RECORD OF DECISION

**Operable Unit 2 of the
Geddes Brook/Ninemile Creek Site
Operable Unit of the Onondaga Lake Bottom Subsite
Onondaga Lake Superfund Site**

OCTOBER 2009

Figure 10
OU2 Site Characteristics

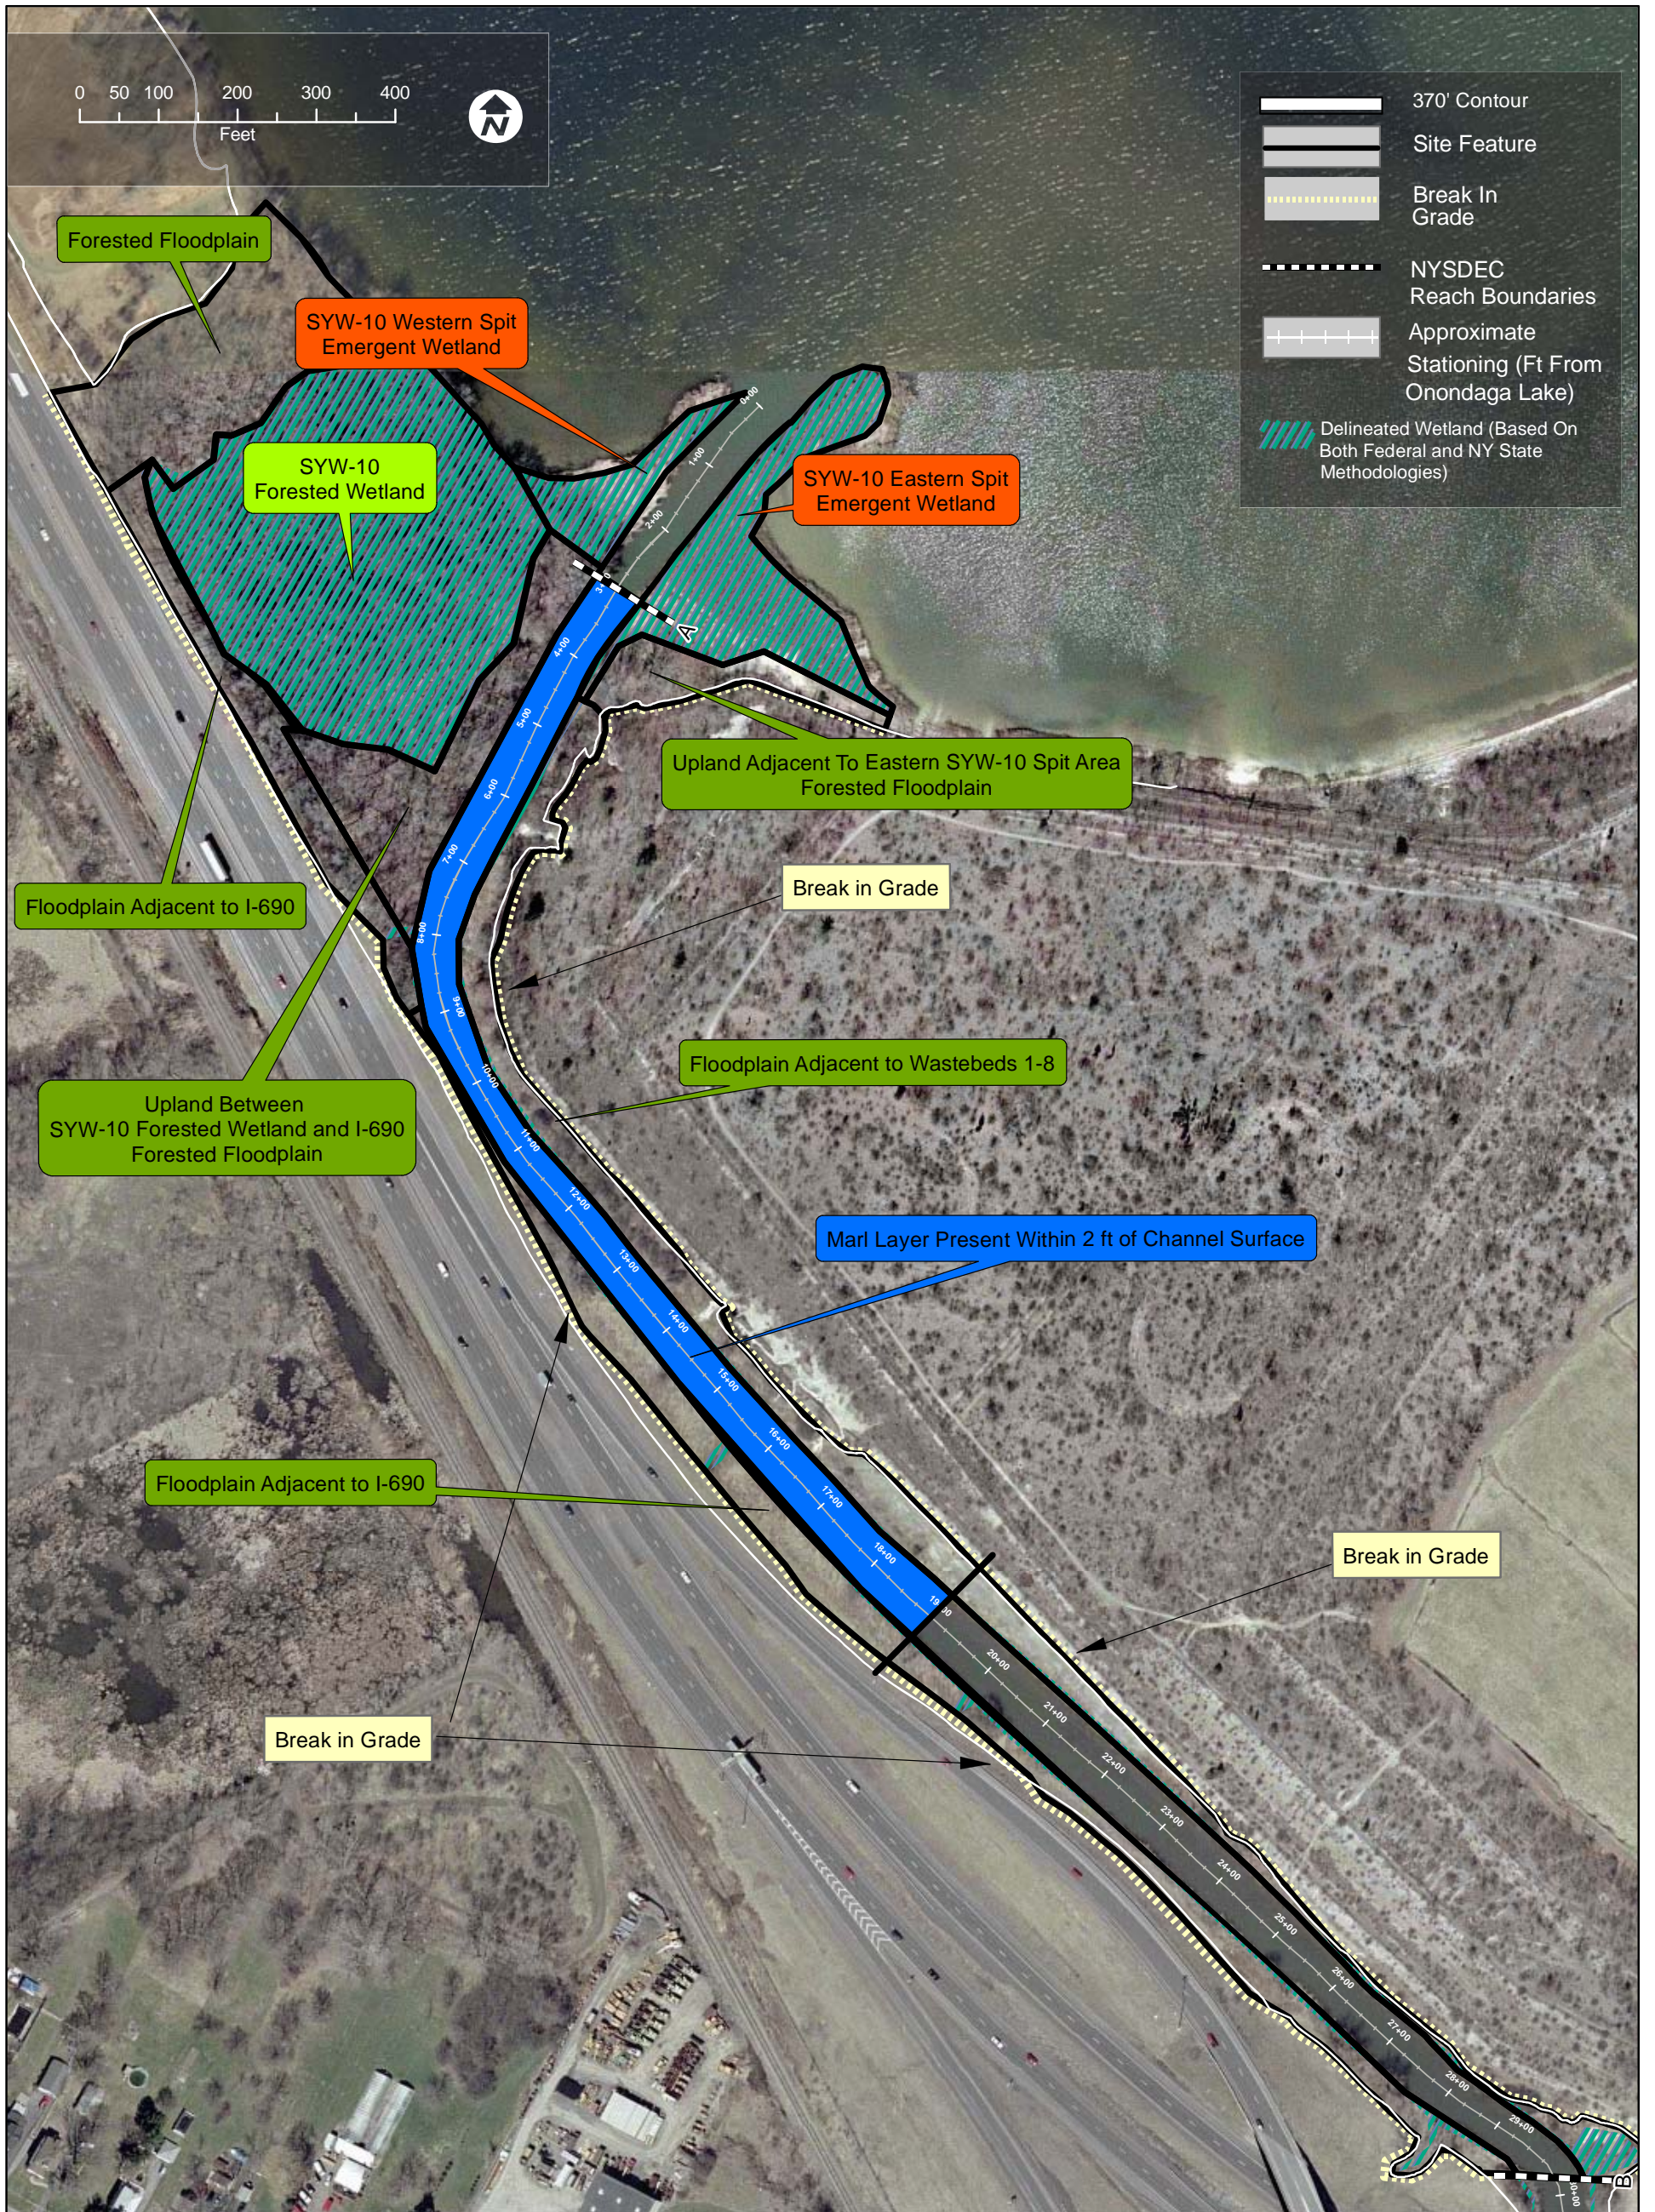
OC8.b. (transcript page 60)	The commenter asked if there is a demarcation for the marl.	The upstream demarcation of the marl within the upper portion of the stream bed is shown on Figure 10 of the ROD and is approximately 1,900 ft (Station 19+00) upstream from the most downstream point of Ninemile Creek (Station 0+00).
Don Hughes	OC9.a. (transcript page 61)	The commenter questioned why the difference in cost between Alternatives 3 and 4 is not proportionate to the difference in volume.	As a result of its deeper removals (up to a depth of 8 ft into the sediments), Alternative 4 would require installation and removal of significantly (greater than ten times) more sheet pile than Alternative 3.
Dereth Glance	OC10.a. (transcript pages 62 and 63)	The commenter questioned the schedule to complete the design.	It is anticipated that preliminary design documents will be submitted in 2010 and that the design of the OU2 remedy will be completed in 2011.

Figure 6. Hexachlorobenzene, transect TN-5

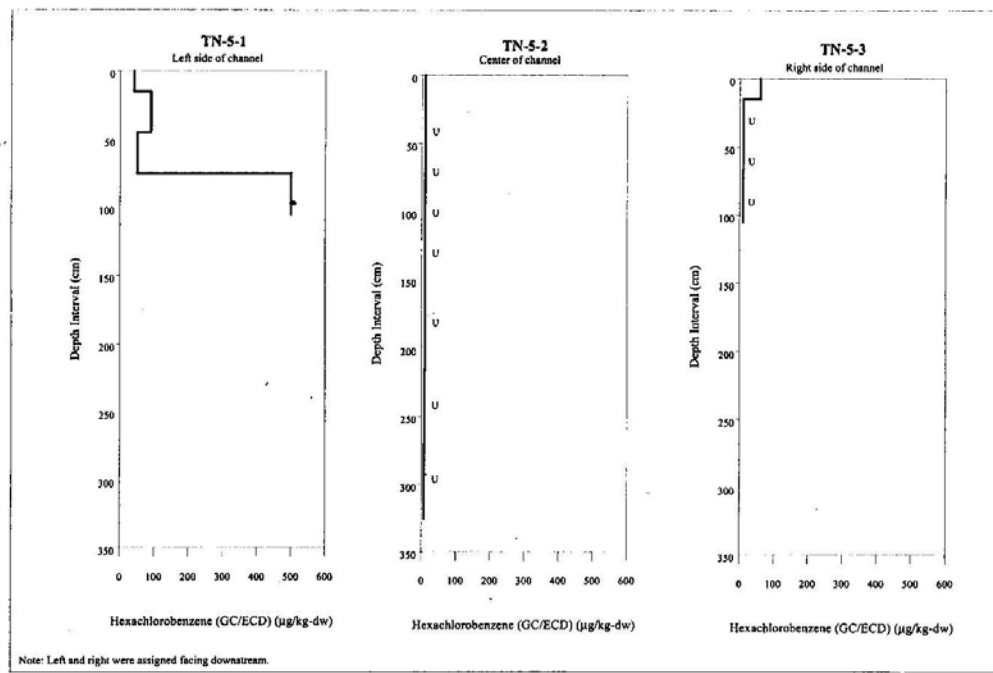
However, other contaminants do not show the same pattern of concentration versus depth. For example, hexachlorobenzene (Figure 6) reaches a maximum concentration of ~500 ug/kg in core TN5-1 a depth of 75-105 cm. This pattern is *completely different* from the pattern observed for mercury. Other contaminants, namely arsenic (Figures 7 and 8) and iron (Figures 9 and 10) also display patterns which are very dissimilar to that of mercury. Note also that arsenic occurs in excess of the Severe Effects Level (33 mg/kg) identified as causing toxicity to benthic life.
